## **Staff Changes**

This section covers changes proposed by Planning Staff to correct errors and to reflect changes in conversion philosophy based on discussions with the PHED Committee and the Planning Board.

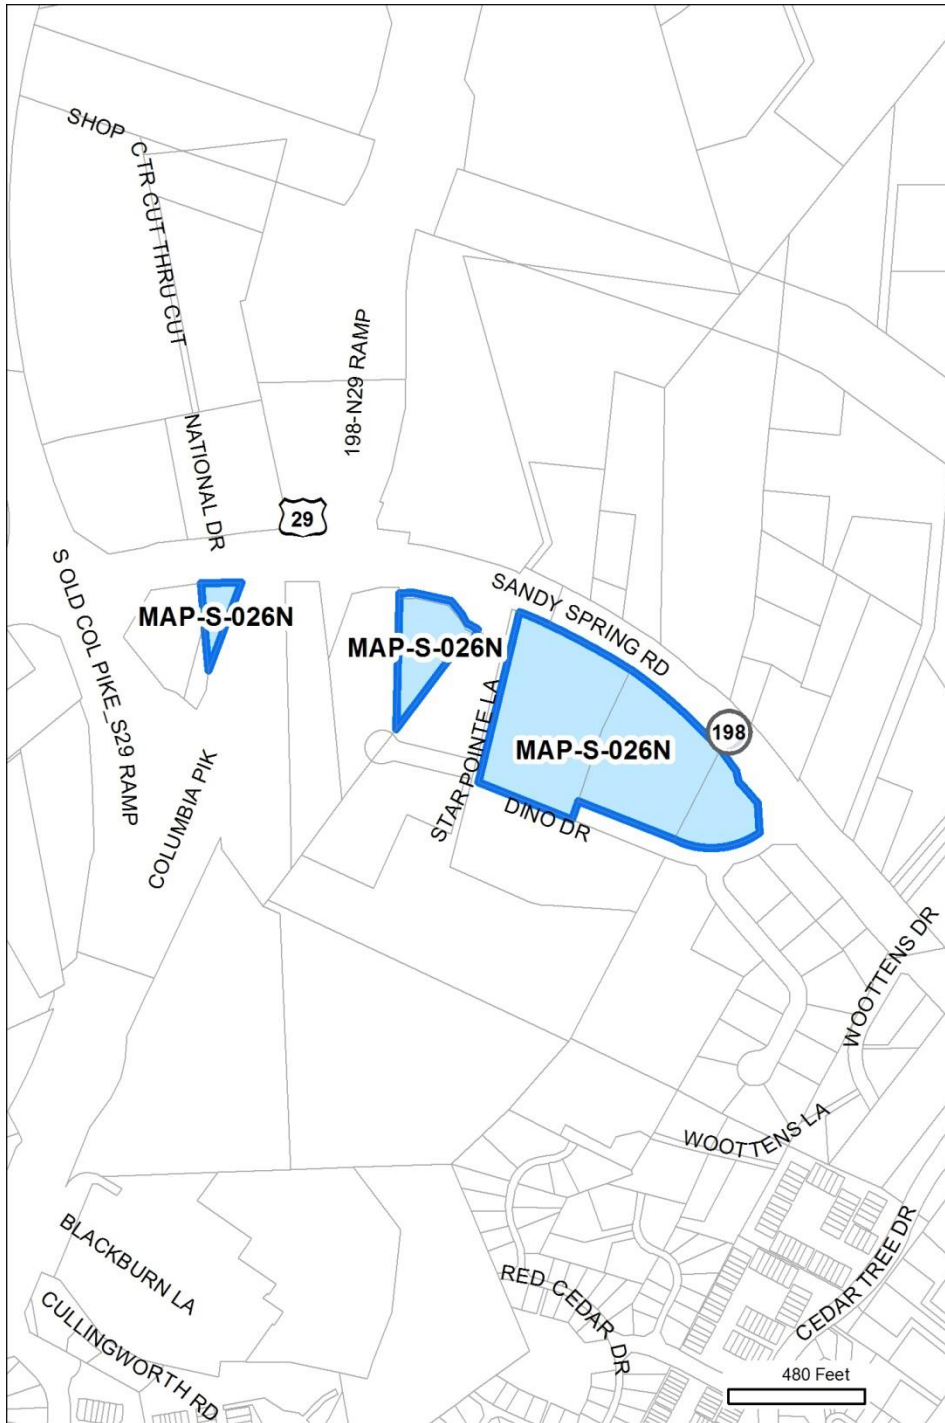
<b>Unique ID:</b> MAP-S-026N		staff rec. change
<b>Master Plan ID:</b> n/a		
<b>Master Plan:</b>		Fairland
<b>Location:</b>		
<b>Existing Zone:</b>		I-1
<b>Proposed Conv:</b> (5/2)		<del>IM-2.5 H-120</del>
<b>Prop. Revised Conv:</b>		IM-2.5 H-50
<b>Category:</b>		Staff Recommendation
<b>Modifications</b>	<b>Zone Group:</b>	No change
	<b>Overall FAR:</b>	No change
	<b>Comm'l FAR:</b>	-
	<b>Resid'l FAR:</b>	-
	<b>Height:</b>	Reduced to 50'
<b>Reason for change:</b>		
<p><i>Since the 5/2 conversion was approved by the Planning Board, staff has received comment from the public and upon further review, believes that the 120' height granted as part of the 5/2 conversion is inappropriate.</i></p> <p><i>The current zoning ordinance allows building heights up to 120' for an "Employment Center", unless the master plan specifically states that an "Employment Center" is inappropriate for the zone – only two master plans contain this restriction.</i></p> <p><i>This provision has been in the code since the last comprehensive revision. Further analysis indicates that buildings up to 120' have not been constructed in the I-1 zone under this provision. Staff proposes a height of 50' for all I-1 property converted to the I-M zone.</i></p>

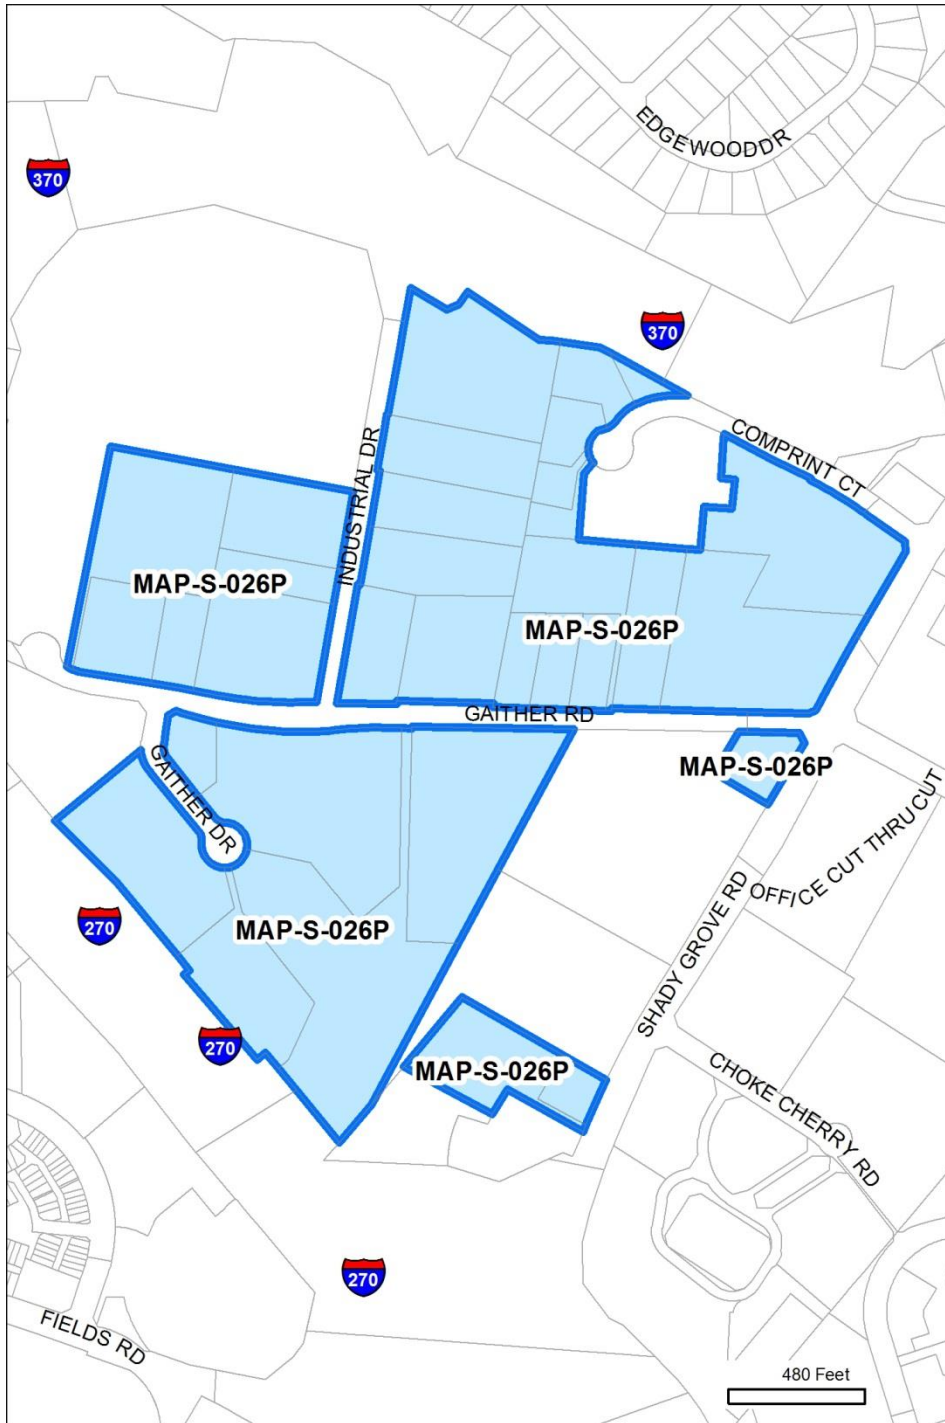
<b>Unique ID:</b> MAP-S-026P		staff rec. change
<b>Master Plan ID:</b> n/a		
<b>Master Plan:</b>	Great Seneca Science Corridor	
<b>Location:</b>		
<b>Existing Zone:</b>	I-1	
<b>Proposed Conv: (5/2)</b>	<del>IM-2.5 H-120</del>	
<b>Prop. Revised Conv:</b>	IM-2.5 H-50	
<b>Category:</b>	Staff Recommendation	
<b>Modifications</b>	<b>Zone Group:</b>	No change
	<b>Overall FAR:</b>	No change
	<b>Comm'l FAR:</b>	-
	<b>Resid'l FAR:</b>	-
	<b>Height:</b>	Reduced to 50'
<b>Reason for change:</b>		
<p><i>Since the 5/2 conversion was approved by the Planning Board, staff has received comment from the public and upon further review, believes that the 120' height granted as part of the 5/2 conversion is inappropriate.</i></p> <p><i>The current zoning ordinance allows building heights up to 120' for an "Employment Center", unless the master plan specifically states that an "Employment Center" is inappropriate for the zone – only two master plans contain this restriction.</i></p> <p><i>This provision has been in the code since the last comprehensive revision. Further analysis indicates that buildings up to 120' have not been constructed in the I-1 zone under this provision. Staff proposes a height of 50' for all I-1 property converted to the I-M zone.</i></p>

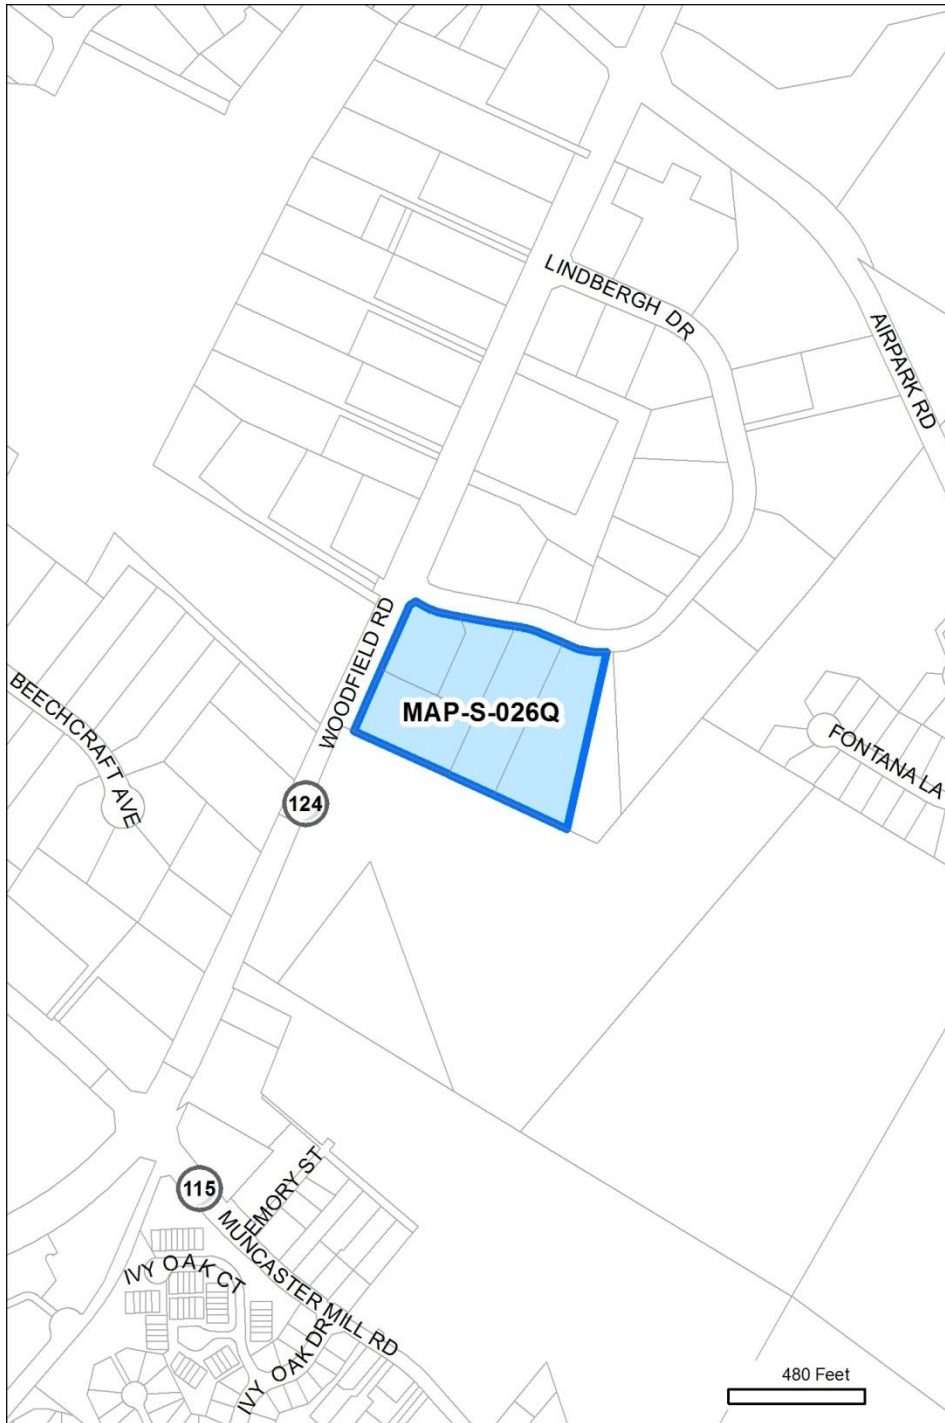
<b>Unique ID:</b> MAP-S-026Q		staff rec. change
<b>Master Plan ID:</b> n/a		
<b>Master Plan:</b>	Upper Rock Creek	
<b>Location:</b>		
<b>Existing Zone:</b>	I-1	
<b>Proposed Conv:</b> (5/2)	<del>IM-2.5 H-120</del>	
<b>Prop. Revised Conv:</b>	IM-2.5 H-50	
<b>Category:</b>	Staff Recommendation	
<b>Modifications</b>	<b>Zone Group:</b>	No change
	<b>Overall FAR:</b>	No change
	<b>Comm'l FAR:</b>	-
	<b>Resid'l FAR:</b>	-
	<b>Height:</b>	Reduced to 50'
<b>Reason for change:</b>		
<p><i>Since the 5/2 conversion was approved by the Planning Board, staff has received comment from the public and upon further review, believes that the 120' height granted as part of the 5/2 conversion is inappropriate.</i></p> <p><i>The current zoning ordinance allows building heights up to 120' for an "Employment Center", unless the master plan specifically states that an "Employment Center" is inappropriate for the zone – only two master plans contain this restriction.</i></p> <p><i>This provision has been in the code since the last comprehensive revision. Further analysis indicates that buildings up to 120' have not been constructed in the I-1 zone under this provision. Staff proposes a height of 50' for all I-1 property converted to the I-M zone.</i></p>

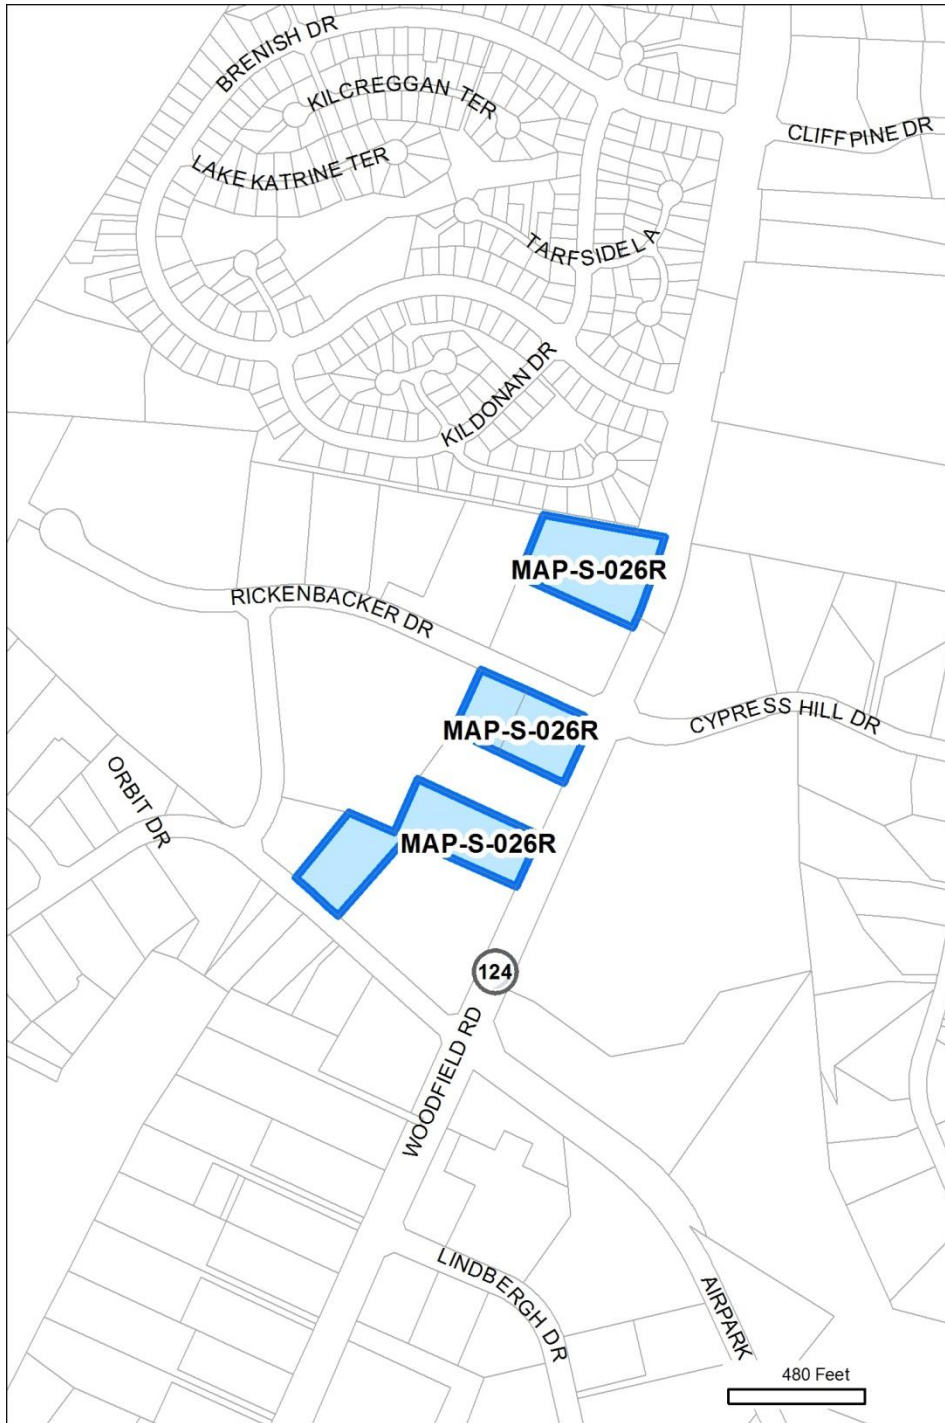
<b>Unique ID:</b> MAP-S-026R		staff rec. change
<b>Master Plan ID:</b> n/a		
<b>Master Plan:</b>	Gaithersburg Vicinity	
<b>Location:</b>		
<b>Existing Zone:</b>	I-1	
<b>Proposed Conv: (5/2)</b>	<del>IM-2.5 H-120</del>	
<b>Prop. Revised Conv:</b>	IM-2.5 H-50	
<b>Category:</b>	Staff Recommendation	
<b>Modifications</b>	<b>Zone Group:</b>	No change
	<b>Overall FAR:</b>	No change
	<b>Comm'l FAR:</b>	-
	<b>Resid'l FAR:</b>	-
	<b>Height:</b>	Reduced to 50'
<b>Reason for change:</b>		
<p><i>Since the 5/2 conversion was approved by the Planning Board, staff has received comment from the public and upon further review, believes that the 120' height granted as part of the 5/2 conversion is inappropriate.</i></p> <p><i>The current zoning ordinance allows building heights up to 120' for an "Employment Center", unless the master plan specifically states that an "Employment Center" is inappropriate for the zone – only two master plans contain this restriction.</i></p> <p><i>This provision has been in the code since the last comprehensive revision. Further analysis indicates that buildings up to 120' have not been constructed in the I-1 zone under this provision. Staff proposes a height of 50' for all I-1 property converted to the I-M zone.</i></p>

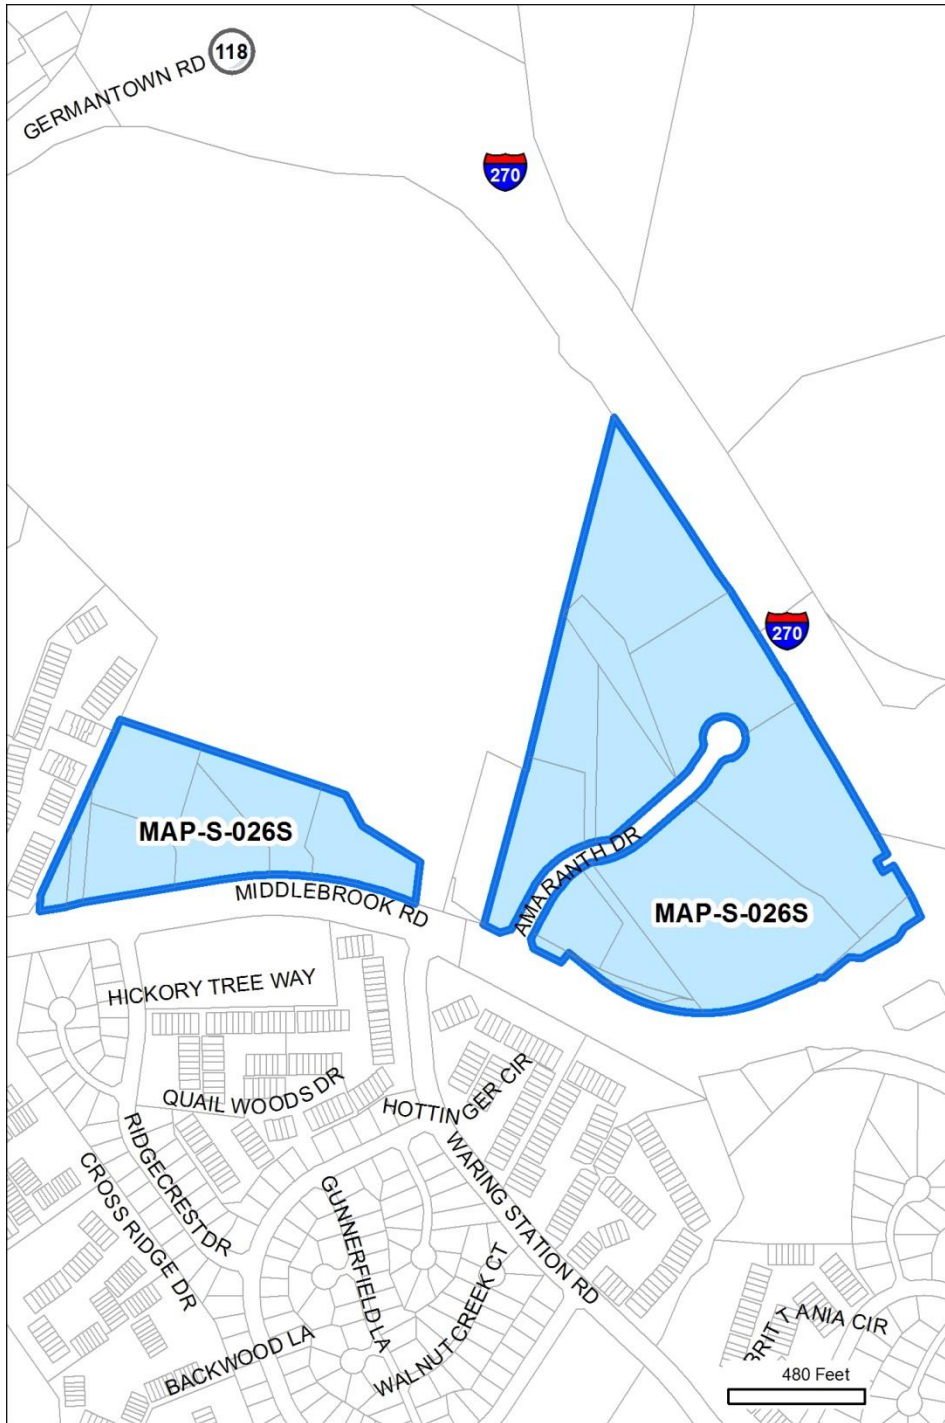
<b>Unique ID:</b> MAP-S-026S		staff rec. change
<b>Master Plan ID:</b> n/a		
<b>Master Plan:</b>	Germantown (2009)	
<b>Location:</b>		
<b>Existing Zone:</b>	I-1	
<b>Proposed Conv:</b> (5/2)	<del>IM-2.5 H-120</del>	
<b>Prop. Revised Conv:</b>	IM-2.5 H-50	
<b>Category:</b>	Staff Recommendation	
<b>Modifications</b>	<b>Zone Group:</b>	No change
	<b>Overall FAR:</b>	No change
	<b>Comm'l FAR:</b>	-
	<b>Resid'l FAR:</b>	-
	<b>Height:</b>	Reduced to 50'
<b>Reason for change:</b>		
<p><i>Since the 5/2 conversion was approved by the Planning Board, staff has received comment from the public and upon further review, believes that the 120' height granted as part of the 5/2 conversion is inappropriate.</i></p> <p><i>The current zoning ordinance allows building heights up to 120' for an "Employment Center", unless the master plan specifically states that an "Employment Center" is inappropriate for the zone – only two master plans contain this restriction.</i></p> <p><i>This provision has been in the code since the last comprehensive revision. Further analysis indicates that buildings up to 120' have not been constructed in the I-1 zone under this provision. Staff proposes a height of 50' for all I-1 property converted to the I-M zone.</i></p>

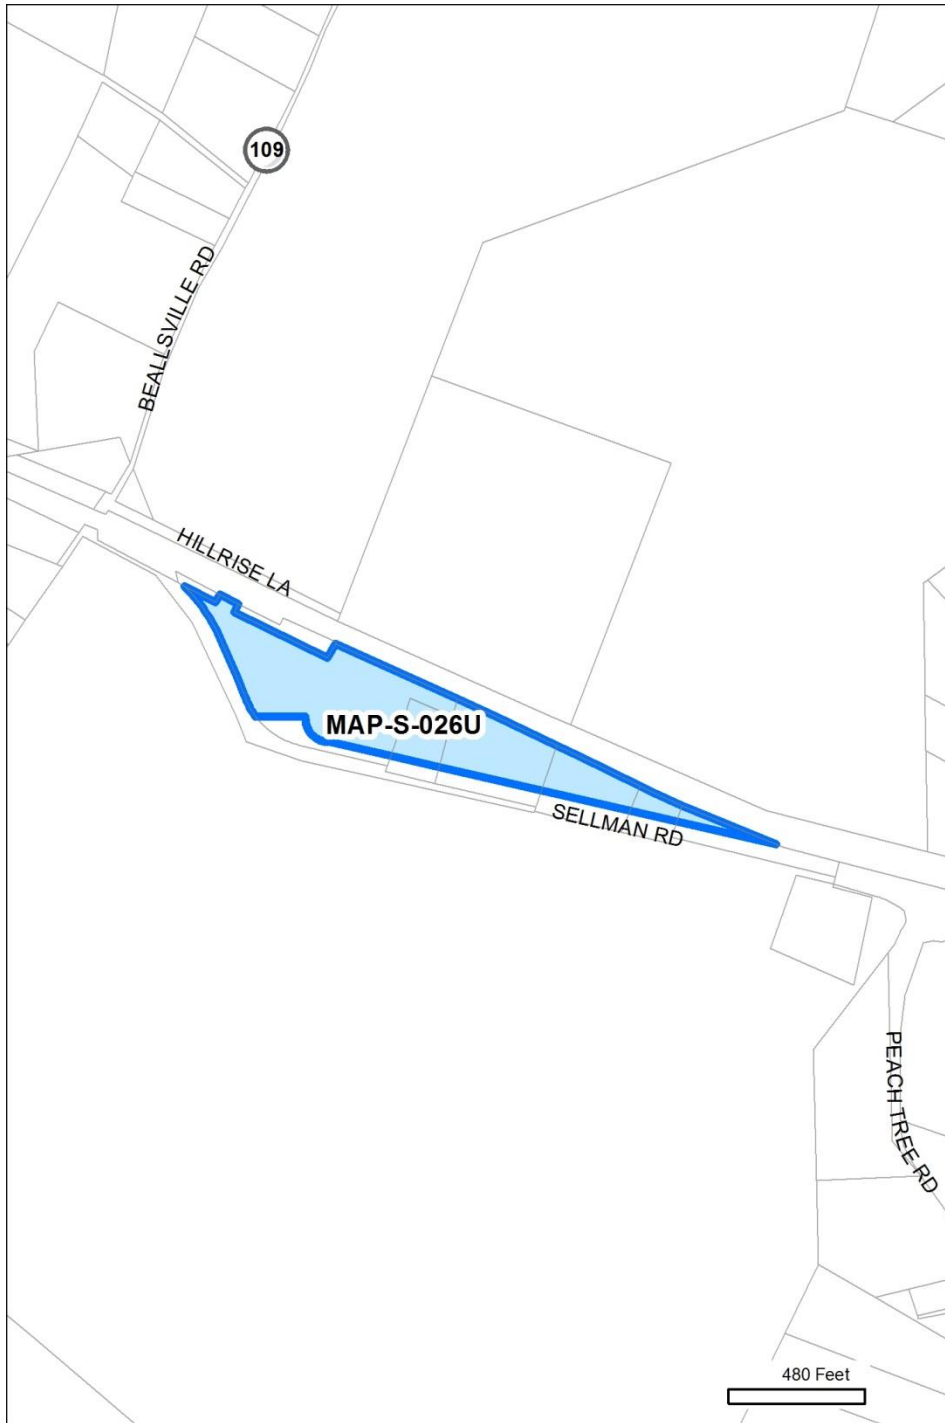
<b>Unique ID:</b> MAP-S-026U		staff rec. change
<b>Master Plan ID:</b> n/a		
<b>Master Plan:</b>	Preservation of Agricultural and Rural Open Sp	
<b>Location:</b>		
<b>Existing Zone:</b>	I-1	
<b>Proposed Conv:</b> (5/2)	<del>IM-2.5 H-120</del>	
<b>Prop. Revised Conv:</b>	IM-2.5 H-50	
<b>Category:</b>	Staff Recommendation	
<b>Modifications</b>	<b>Zone Group:</b>	No change
	<b>Overall FAR:</b>	No change
	<b>Comm'l FAR:</b>	-
	<b>Resid'l FAR:</b>	-
	<b>Height:</b>	Reduced to 50'
<b>Reason for change:</b>		
<p><i>Since the 5/2 conversion was approved by the Planning Board, staff has received comment from the public and upon further review, believes that the 120' height granted as part of the 5/2 conversion is inappropriate.</i></p> <p><i>The current zoning ordinance allows building heights up to 120' for an "Employment Center", unless the master plan specifically states that an "Employment Center" is inappropriate for the zone – only two master plans contain this restriction.</i></p> <p><i>This provision has been in the code since the last comprehensive revision. Further analysis indicates that buildings up to 120' have not been constructed in the I-1 zone under this provision. Staff proposes a height of 50' for all I-1 property converted to the I-M zone.</i></p>
